**Addendum No. 1**

**Subject:** General Louis Wagner Middle School Culinary Art Suite Renovation  
SDP Contract Nos. B-022C, B-023C, B-024C, B-025C

**Location:** General Louis Wagner Middle School  
1701 W Chelton Ave  
Philadelphia, Pennsylvania 19139

**This Addendum, dated 1 of April, 2021, shall modify and become part of the Contract Documents for the work of this project. Any items not mentioned herein, or affected by, shall be performed strictly in accordance with the original documents.**

DRAWING TITLE  
**SINGLE LINE DIAGRAM**

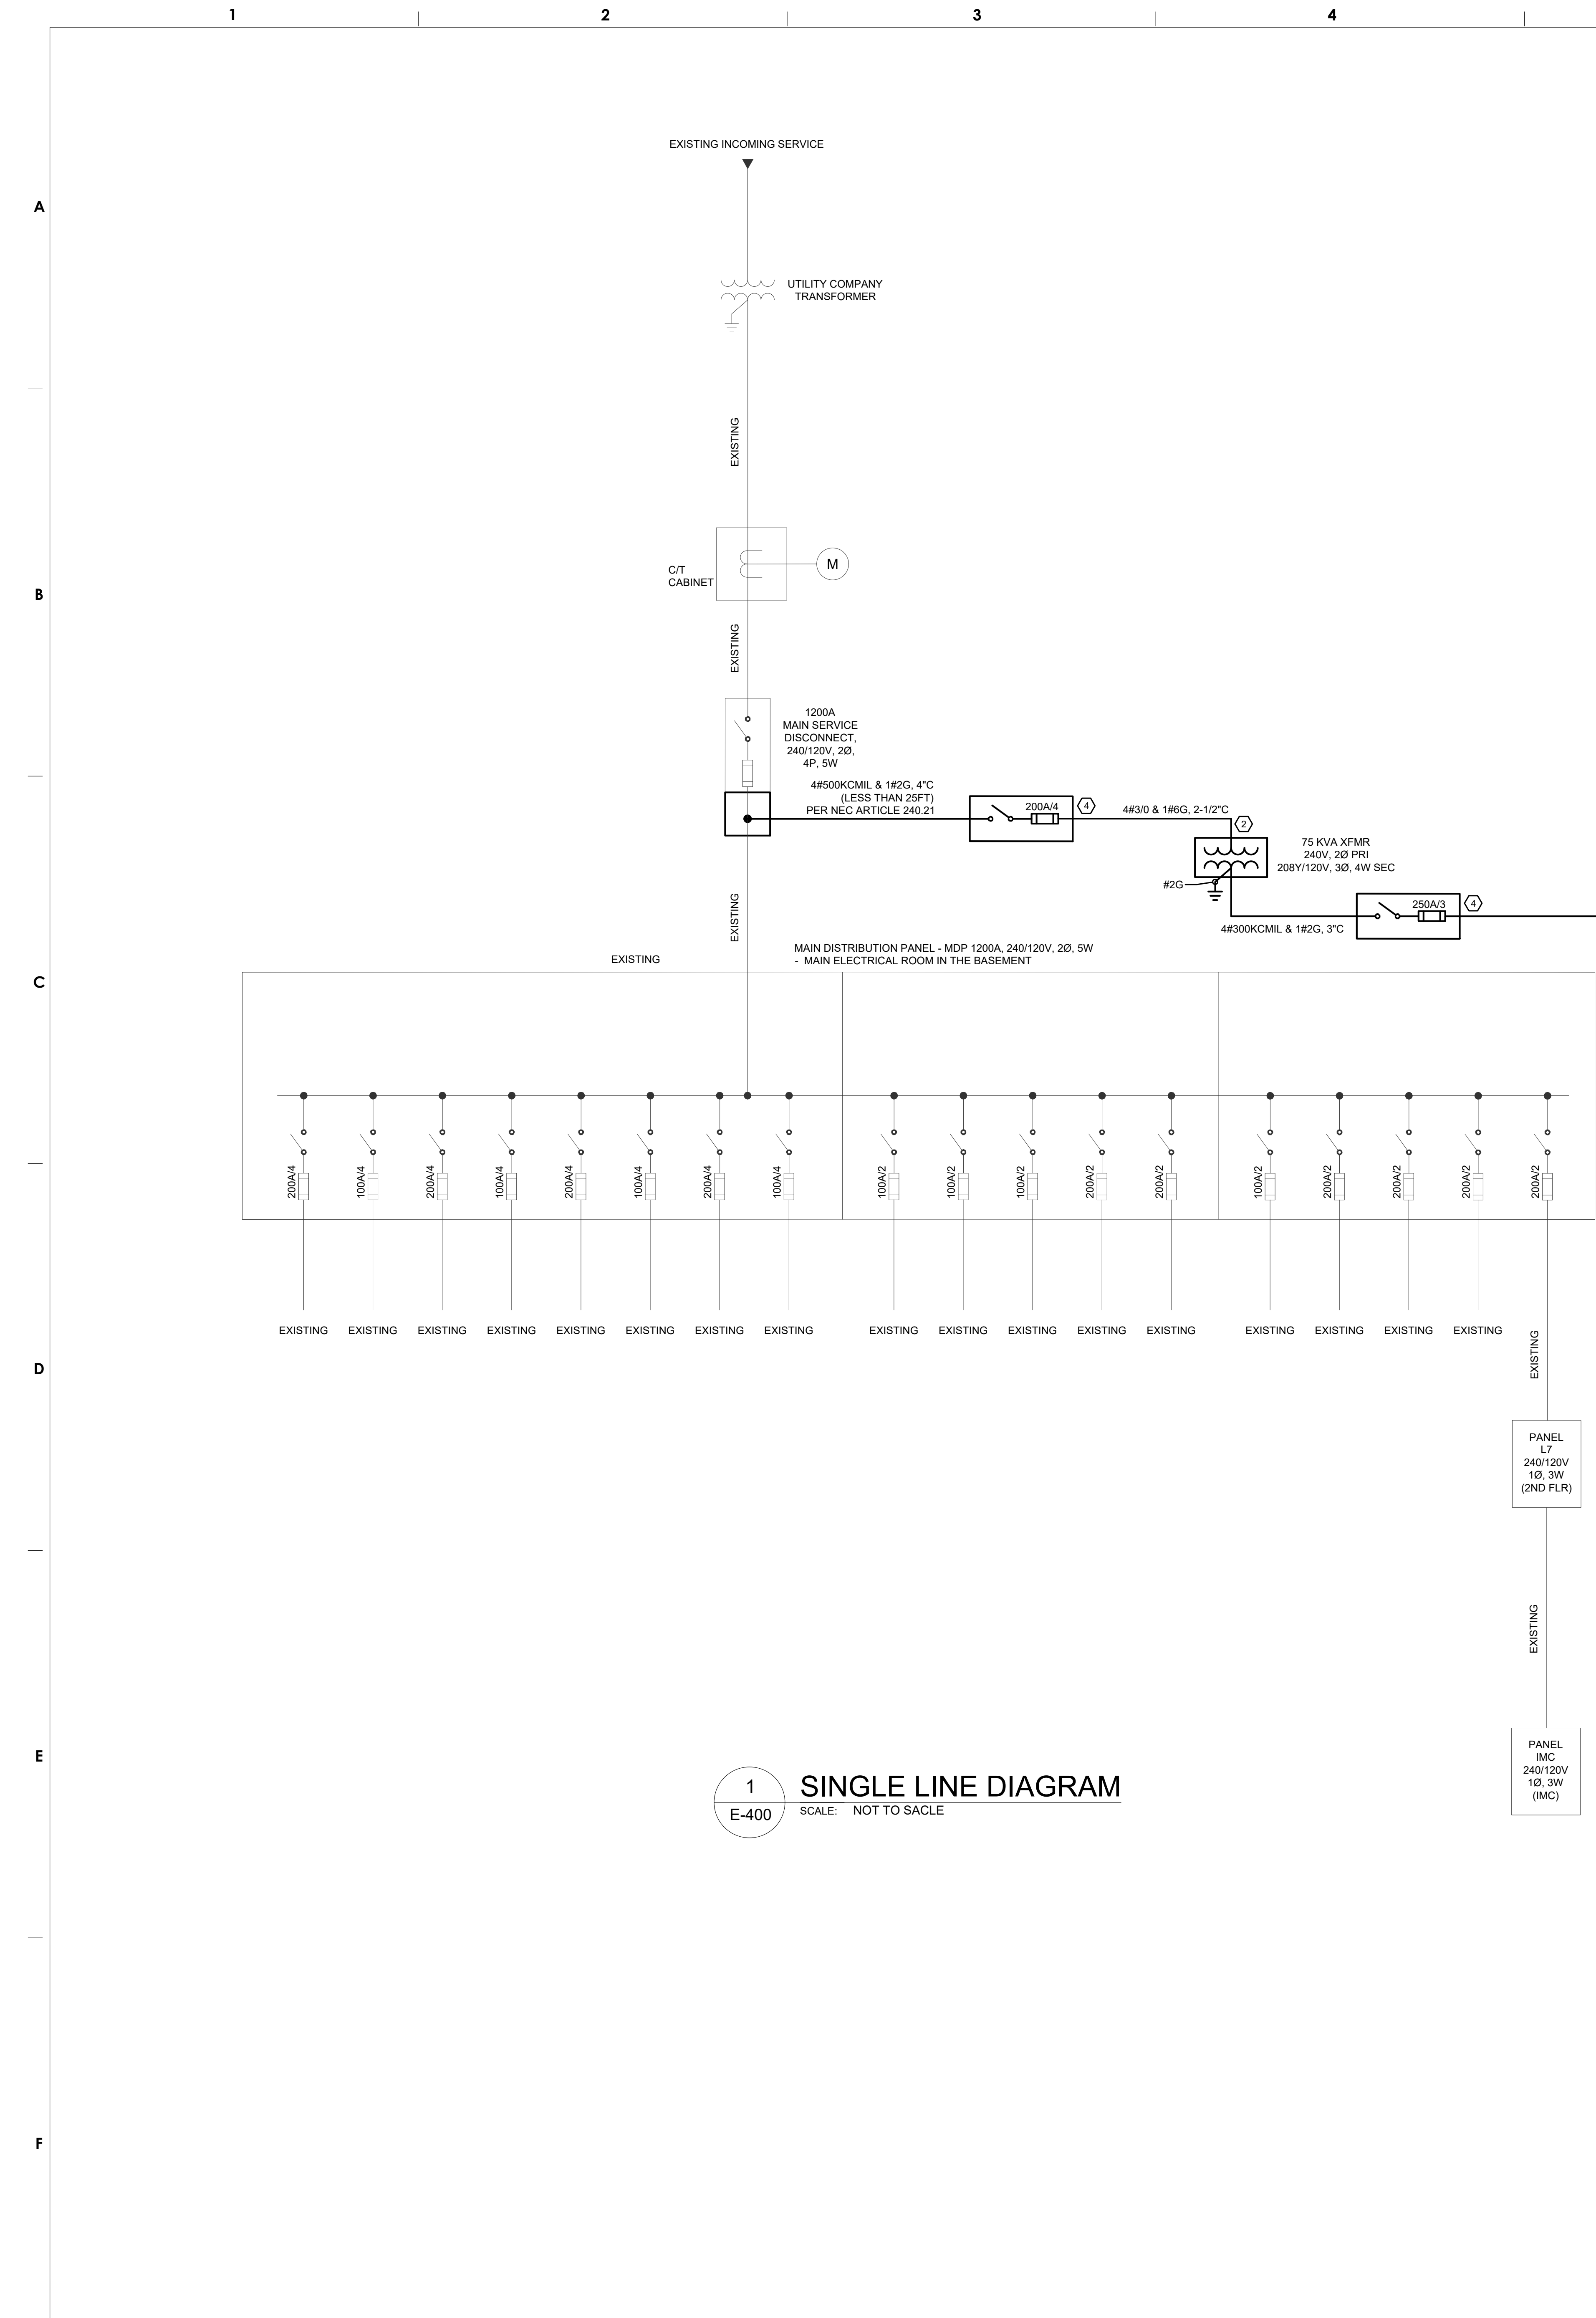
#### **Drawing: E-400 Single Line Diagram**

- a. Updated Panel 209 to be 60 circuit panelboard.
- b. Added new circuit for countertop receptacle at instructor's demonstration area.

Question 8: On Drawing E-400, who provides the housekeeping pad for the transformer?

Question 9: On Drawing E-400, the panel schedule for Pnl 209 skips from 48 to 67. Is this supposed to be a 72 circuit panelboard or a 54 circuit panelboard?

**Answer 8: Housekeeping pad provided by E.C.**

**Answer 9: Panel 209 shall be a 60 circuit panelboard. Refer to addendum 1.**

LOCATION NO.	
DRAWN BY NIP	CHECKED BY GSP
GC - B-022 C	OF 2020 / 21
MC - B-023 C	OF 2020 / 21
PC - B-024 C	OF 2020 / 21
EC - B-025 C	OF 2020 / 21
DRAWING NO.	<b>E - 510</b>
SHEET	22 OF 23

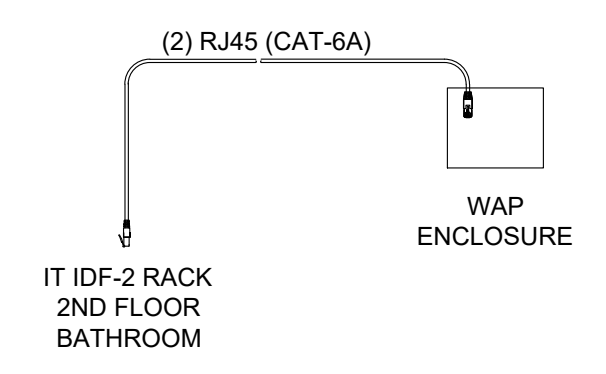
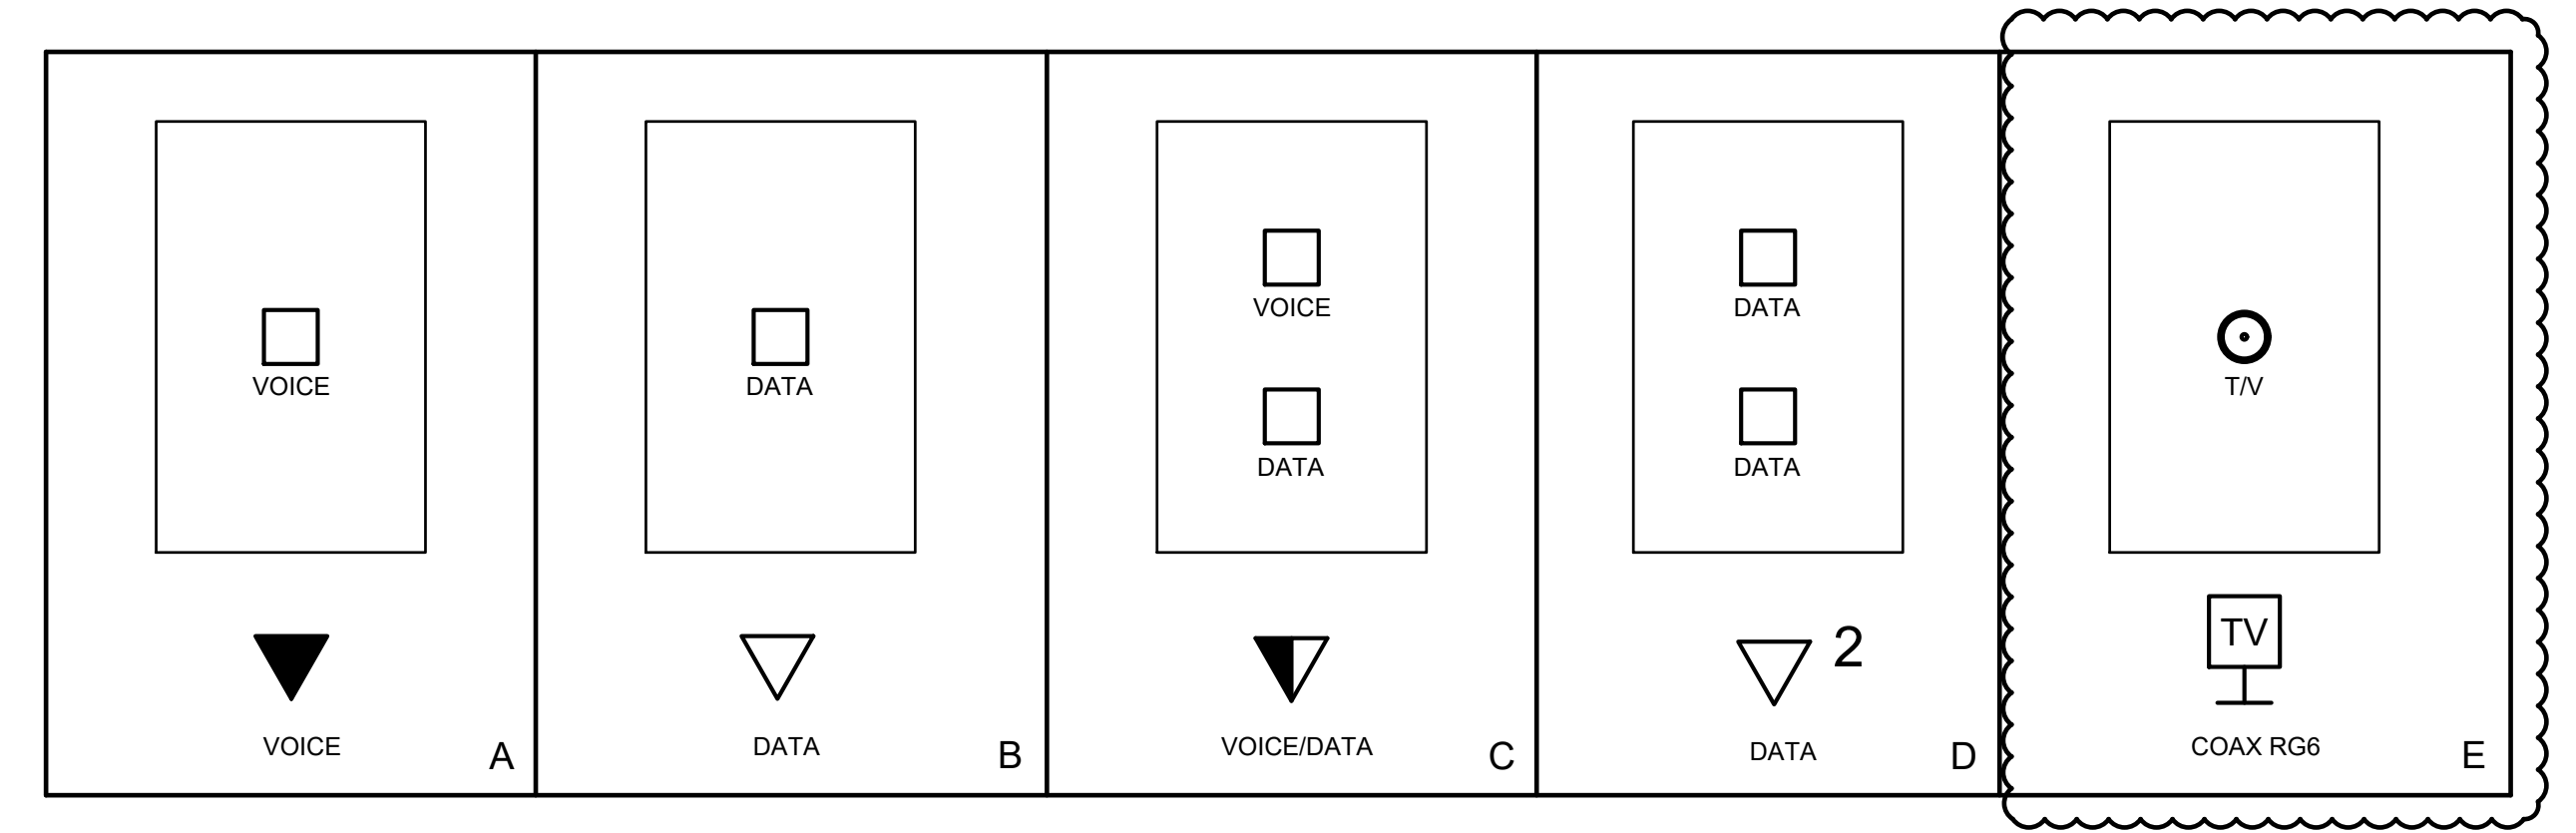
#### **Drawing: E-510 Electrical Details**

- a. Updated matrix to show CATV.

Question 18: For the monitors over the instructor's station, how many cables and jacks are required since the symbol is not shown on Drawing E-000?

**Answer 18: For each monitor – provide duplex receptacle, CATV outlet, and a single data jack with 1-CAT-6A cable. See drawing E-510 for more information.**

DRAWING NO.  
**E - 520**  
SHEET 23 OF 23

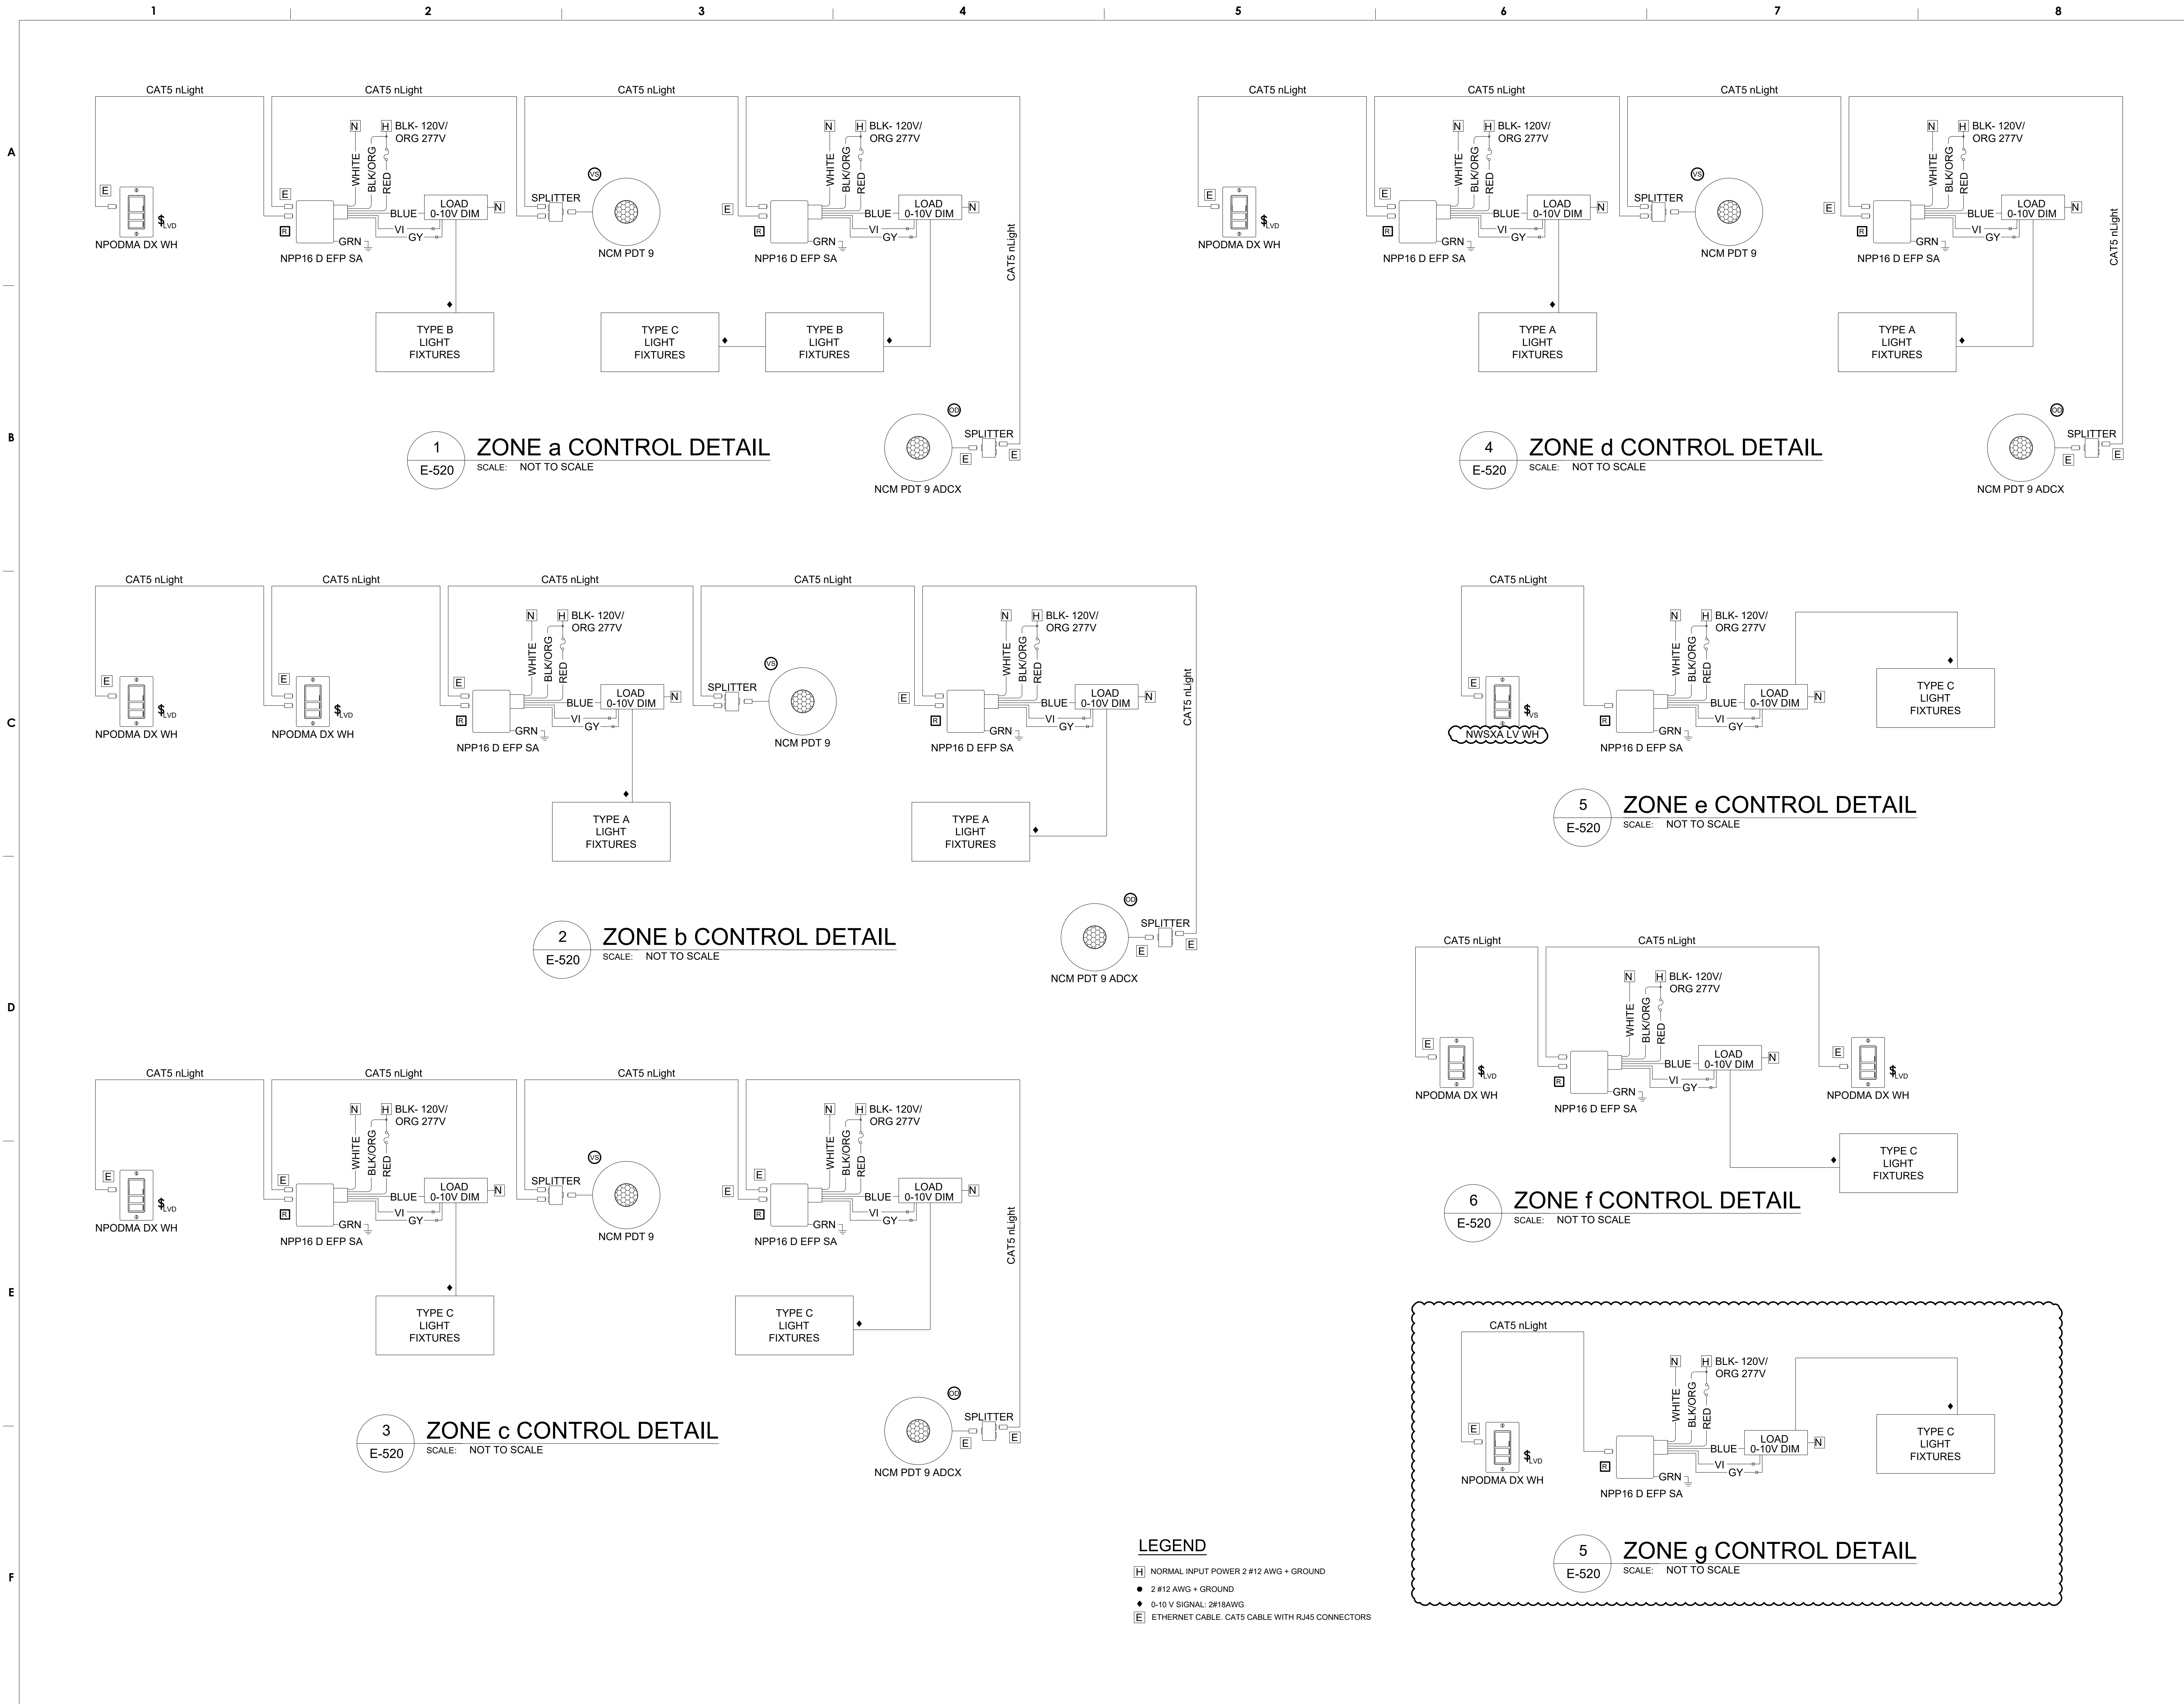
#### **Drawing: E-520 Electrical Zone Lighting Control Details**

- a. Added wiring diagram for zone g.
- b. Updated model # for \$<sub>vs</sub>.
